Modification Bulletin

[60-0007][MB][EUR][YT3][DT] Front axle mounting check

09 November 2023

**Front axle mounting check
YTxx3, DT**

✔ YTx3 situation :

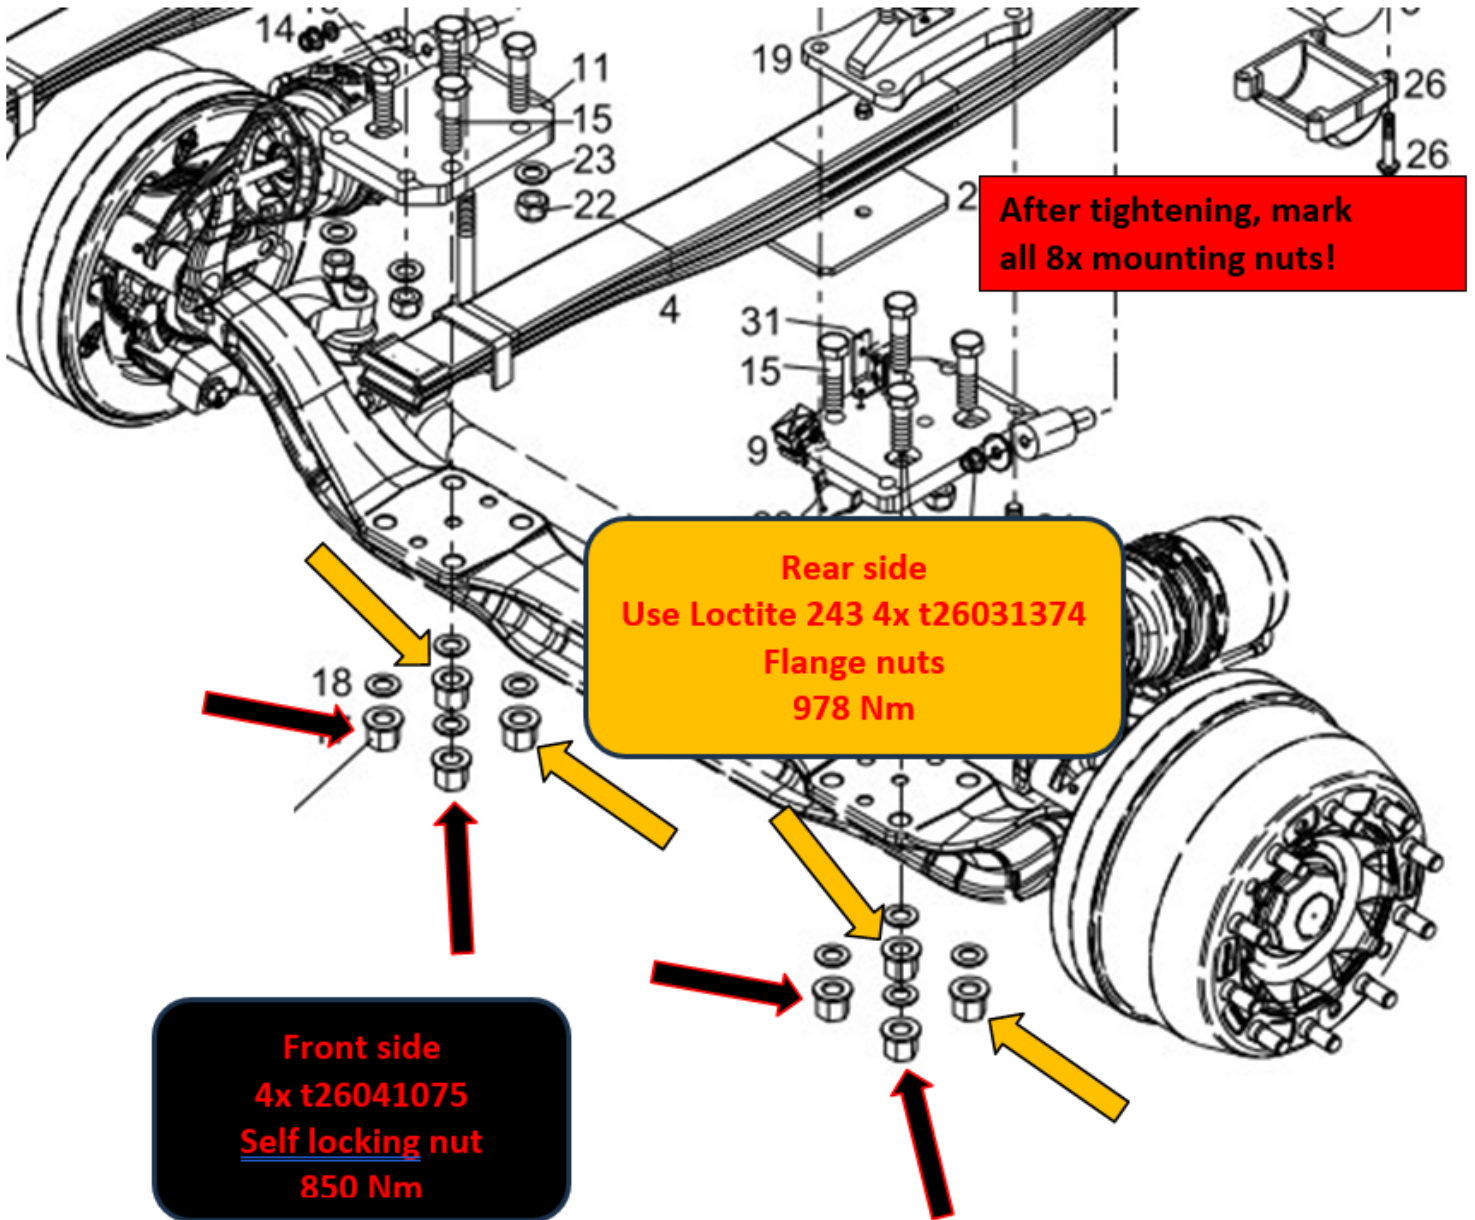
Use 4 times a non self locking nut with Loctite 243 on the rear side of the axle where space is limited, and 4 self locking nuts for the remaining positions.

For information: The non self locking nut has spanner size 32 and the self locking nut t26041075 has spanner size 36.

On all vehicles built with 8 flange nuts on the front axle a modification must be made. Please read the instructions below carefully.

For the **YTxx3**: when 4 self locking nuts and 4 non self locking nuts are mounted the machines was reworked/produced according to the most recent standard and is considered okay.

1. Park the vehicle in a safe place.
2. Place wheel chocks on the rear wheels.
3. Disconnect the main switch and make sure no one can start the vehicle unintended
4. Check if the machine has 8 non self locking flange nuts, spanner width 32mm.
5. Change the 4 nuts on the front side of the axle to normal self locking nuts t26041075, torque these to 850Nm.
6. For **YTxx3** (for **DTxx3** go to step 7): Undo the other 4 flange nuts on the rear side of the axle, apply Loctite 243 and torque to 978Nm.
7. For **DTxx3** (For **YTxx3** go to step 8): Replace the 4 nuts on the rear side of the axle for self locking nuts t26041075, torque these to 850Nm.
8. Retorque nuts on the front side to 850Nm.
9. Mark all nuts with a marker after tightening.

✔ DT Situation :

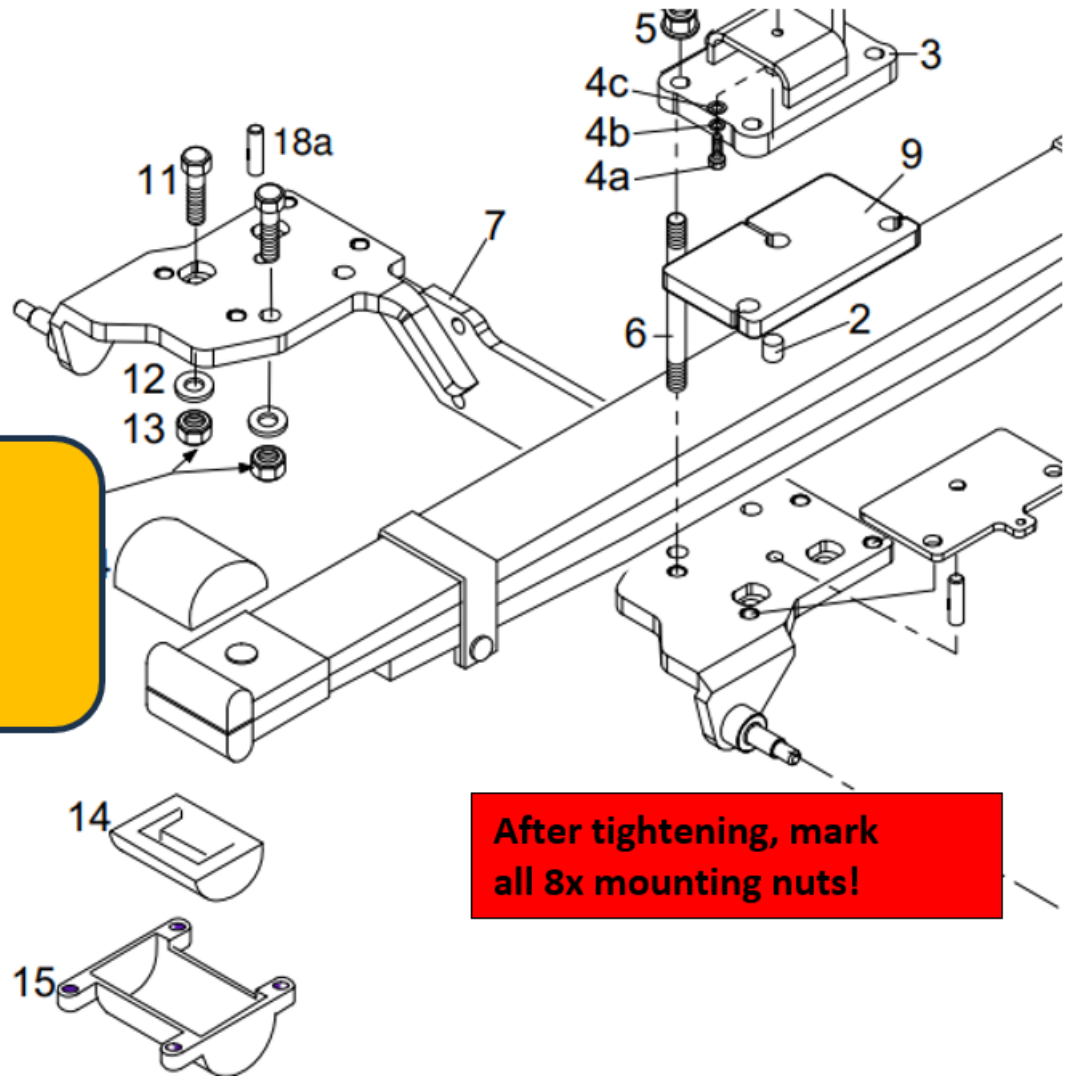
Use 8 times self locking nut t26041075 with spanner size 36.

For the **DTxx3**: when 8 self locking nuts are mounted the machine is assembled to the correct standards and is considered okay.

8x t26041075
Self locking nut
850 Nm

After tightening, mark all 8x mounting nuts!
